Access Compliance Report

Public Rights-of-Way

(Curb Ramps)

Intersection ID: 12998	Main Street: 5TH_ST	Cross Street: MCDOWELL_ST	Location: S
ADA ID: 803CF6F96117	Ramp Type: Perp	Initial Pass/Fail: Fail	Overall Compliance: No
Severity Score: 13.75			
Codes/Mitigation Info/Possible Solution		Field Measurements/Component Compliance

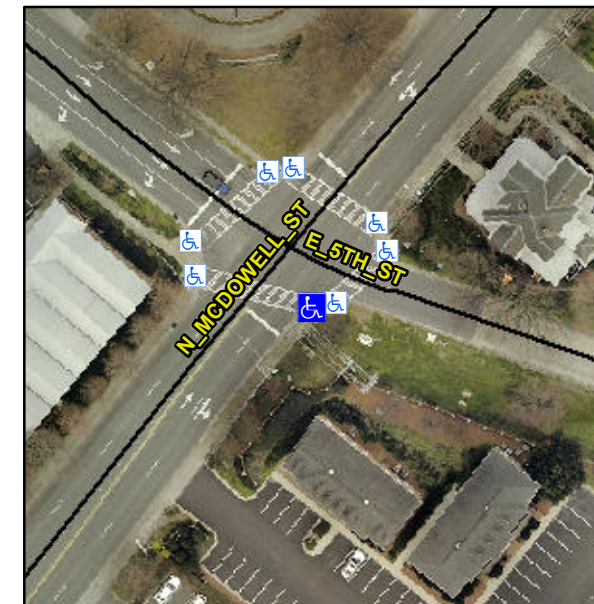
Not Found, R304.2.2, R304.5.3

Compliance	Description	Data	Compliance	Description	Data
N/A	Ramp Length (in)	71.0	No	Ramp Slope (%)	8.4
Yes	Ramp Width (in)	48.0	No	Ramp XSlope (%)	5.0
N/A	Flare Type LT	N/A	N/A	Flare Type RT	N/A
N/A	Flare Slope LT (%)	N/A	N/A	Flare Slope RT (%)	N/A
N/A	Flare Traversable LT?	N/A	N/A	Flare Traversable RT?	N/A
N/A	Landing Length (in)	N/A	N/A	DWS Provided?	N/A
N/A	Landing Width (in)	N/A	N/A	DWS Contrast?	N/A
N/A	Landing Slope (%)	N/A	N/A	DWS Length (in)	N/A
N/A	Landing X Slope (%)	N/A	N/A	DWS Full Width?	N/A
N/A	Landing Curb? (Y/N)	N/A	N/A	DWS Offset (in)	N/A
N/A	Shared Landing?	N/A			
N/A	Gutter Ponding?	N/A	N/A	Gutter Slope (%)	N/A
N/A	Gutter Lip Ht (in)	N/A	N/A	Gutter X Slope (%)	N/A
N/A	Painted X Walk1?	Yes	N/A	Painted X Walk2?	N/A
	X Walk 1 Direction	To NW		X Walk 2 Direction	N/A
N/A	X Walk 1 Width (in)	100.0	N/A	X Walk 2 Width (in)	N/A
	X Walk 1 Slope (%)	1.7		X Walk 2 Slope (%)	N/A
	X Walk 1 X Slope (%)	0.6		X Walk 2 X Slope (%)	N/A

Remove & Replace Entire Ramp.
